SUMMARY OF CHANGES BETWEEN CONSENTED PLANNING DRAWINGS, AS PER APPLICATION REF 132952/JO/2022 AND PROPOSED SECTION 73 APPLICATION DRAWINGS:

Project Title
T2 VITA LIVING, ST. JOHNS

Drawing Title
PROPOSED NORTH ELEVATION

Drawing Number
6555-P-B500-E-N

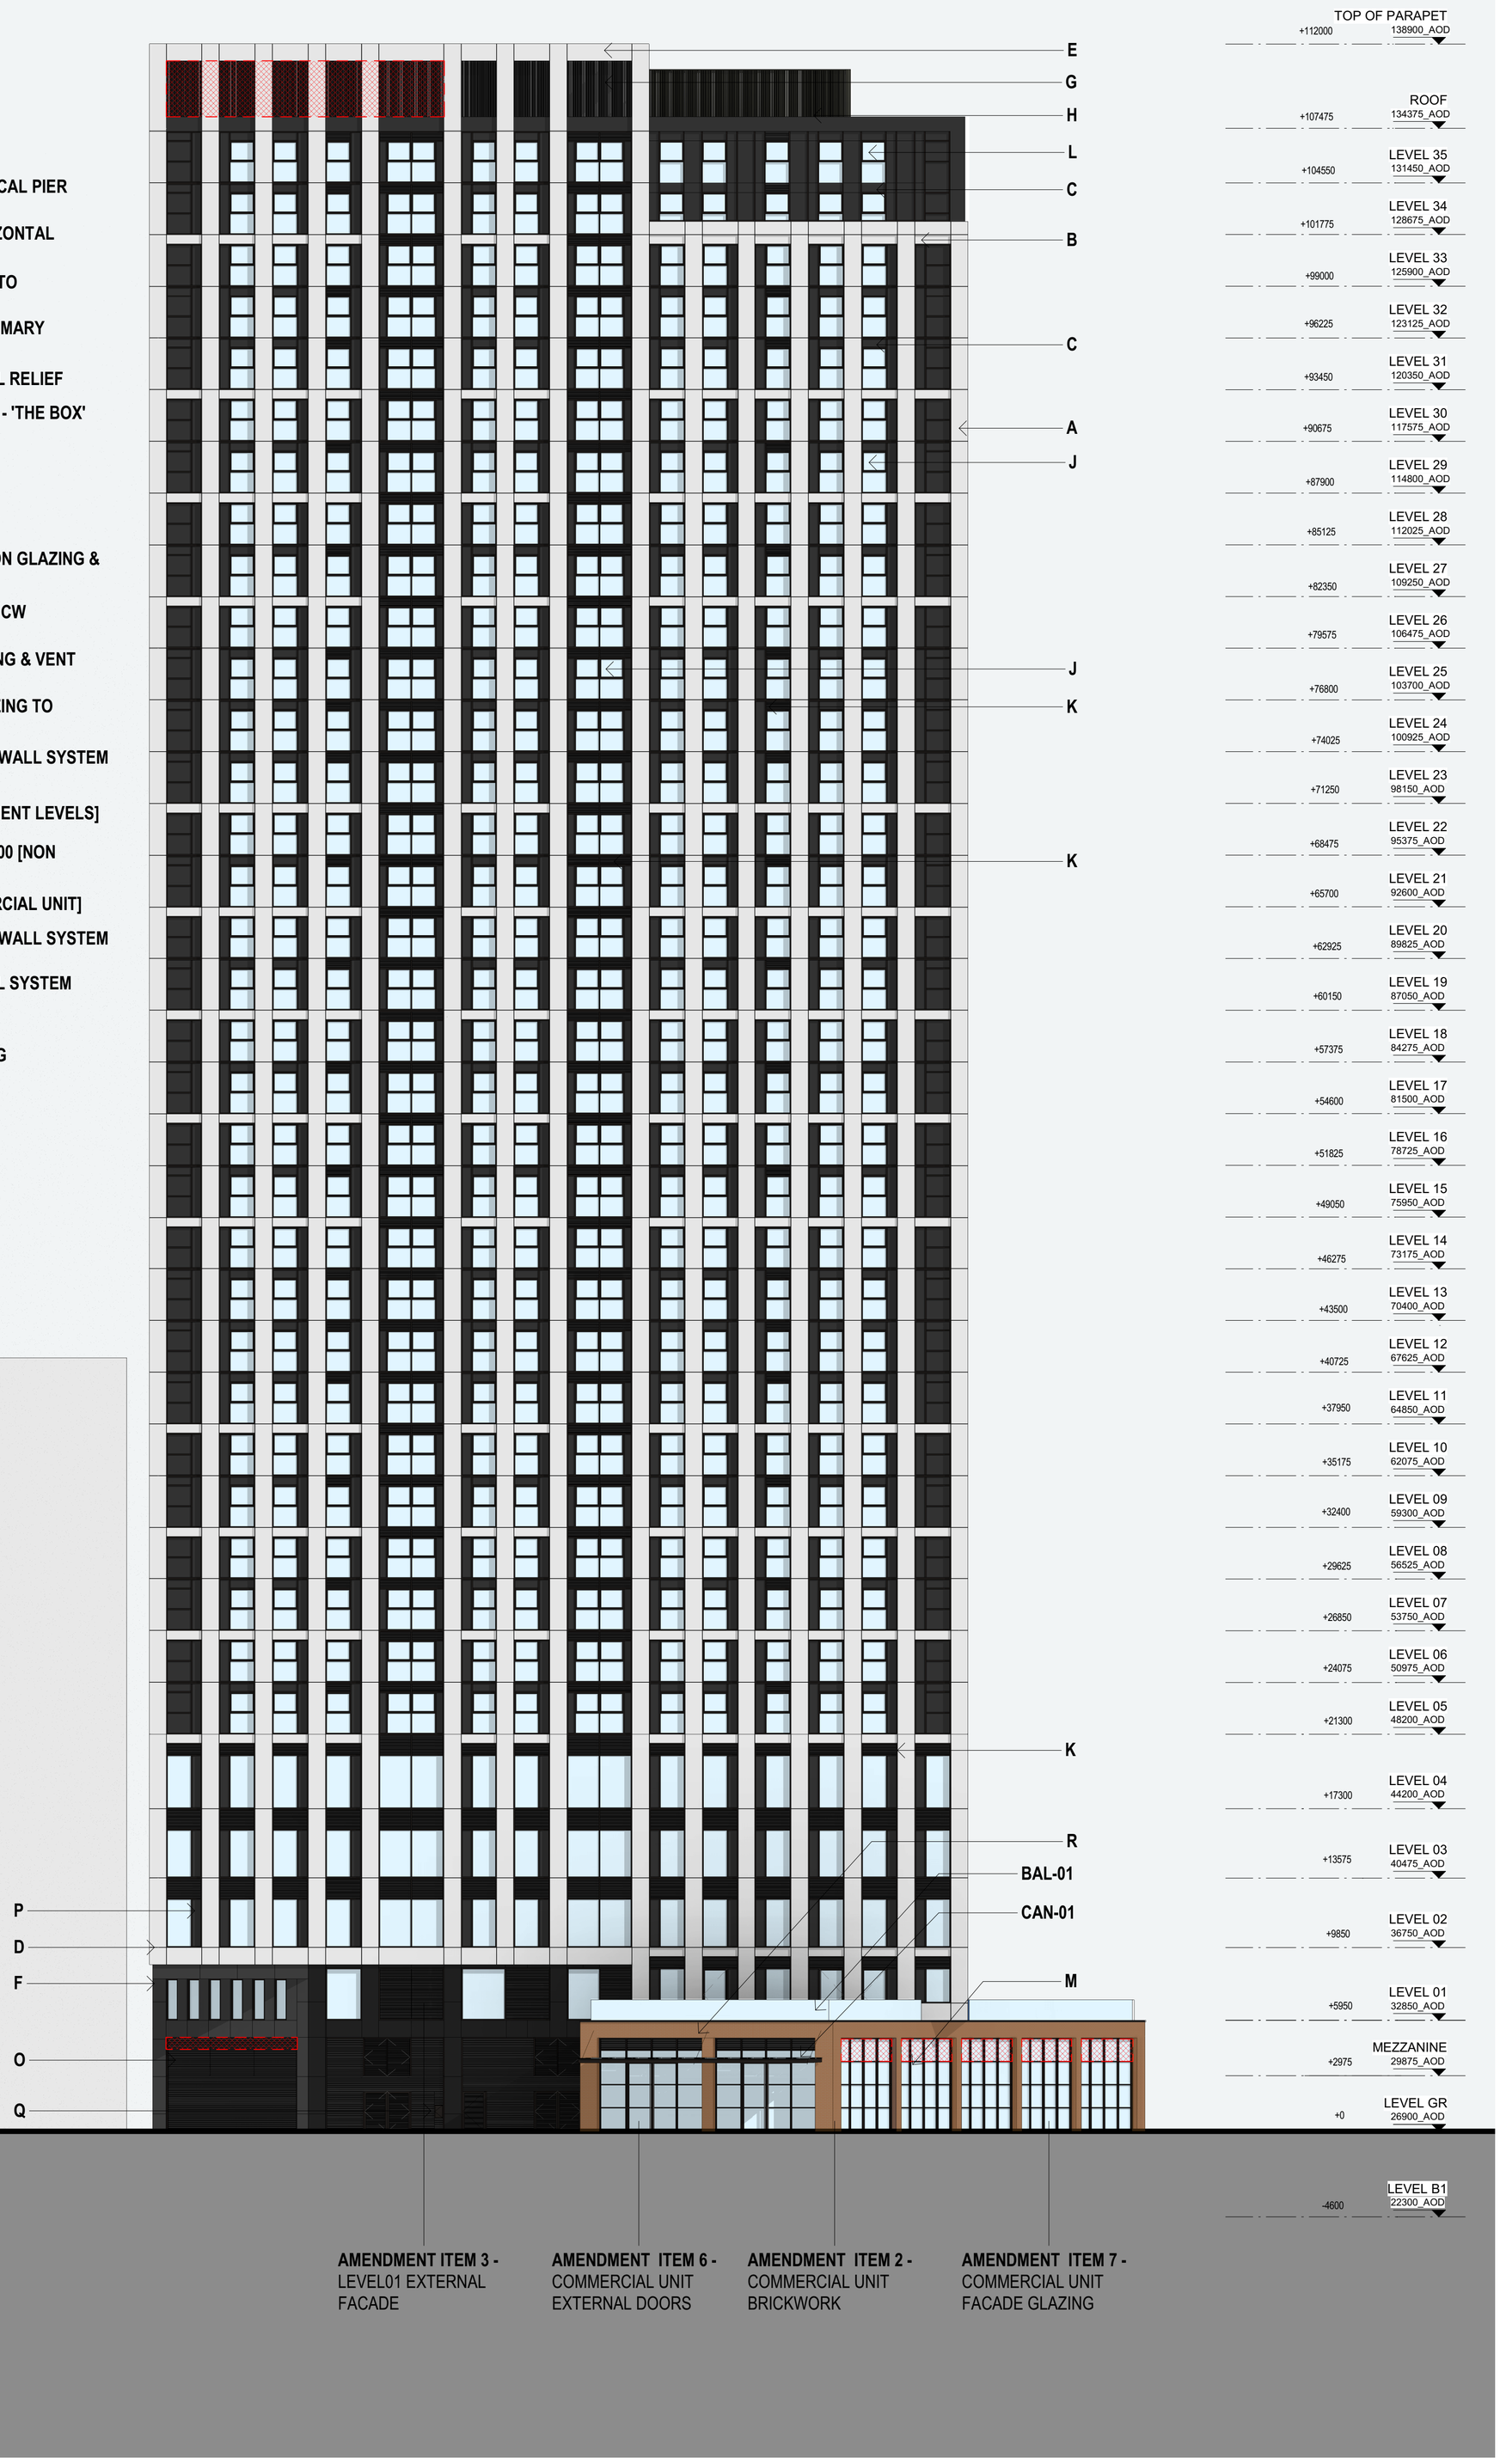
1 – WIND MITIGATION
WIND MITIGATION SCHEME AMENDED.

2 - COMMERCIAL UNIT BRICKWORK
EXTERIOR FACING BRICKWORK AMENDED FROM CERAMIC GREEN TO CLAY 'RED MULTI' MASONRY.

3 – LEVEL 01 EXTERNAL FACADE
FULL HEIGHT GLAZING PANELS SUBSTITUTED WITH LOUVRE PANEL TO SUIT INTERNAL LAYOUT

4 – GROUND FLOOR EXTERNAL FAÇADE
HEIGHT OF TRANSFORM TO GROUND FLOOR CURTAIN WALLING DROPPED BY C.400MM

5 – MAIN ENTRANCE 'PORTAL' DOOR
OUTER SLIDING DOOR ALIGNED WITH MAIN FACADE LINE. GLAZING AROUND DOOR SUBSTITUTED WITH PERFORATED DECORATIVE PANELS TO INCORPORATE INTERNAL NATURAL VENTILATION RISER. GLAZED PANEL TO OUTER AND INNER DOOR AMENDED TO ALIGN WITH CONSENTED DESIGN FOR T1 (REF.136508/NMC/2023).

6 – COMMERCIAL UNIT EXTERNAL DOORS
POSITION OF COMMERCIAL UNIT MAIN ENTRANCE DOOR AMENDED. SIZE AND SWING OF EXTERNAL DOORS TO NORTH ELEVATION OF COMMERCIAL UNIT AMENDED.

7 - COMMERCIAL UNIT FACADE GLAZING
EXTENT OF LOUVRES IN CURTAIN WALLING TO COMMERCIAL UNIT RATIONALISED. FULL HEIGHT GLAZING TO WEST ELEVATION
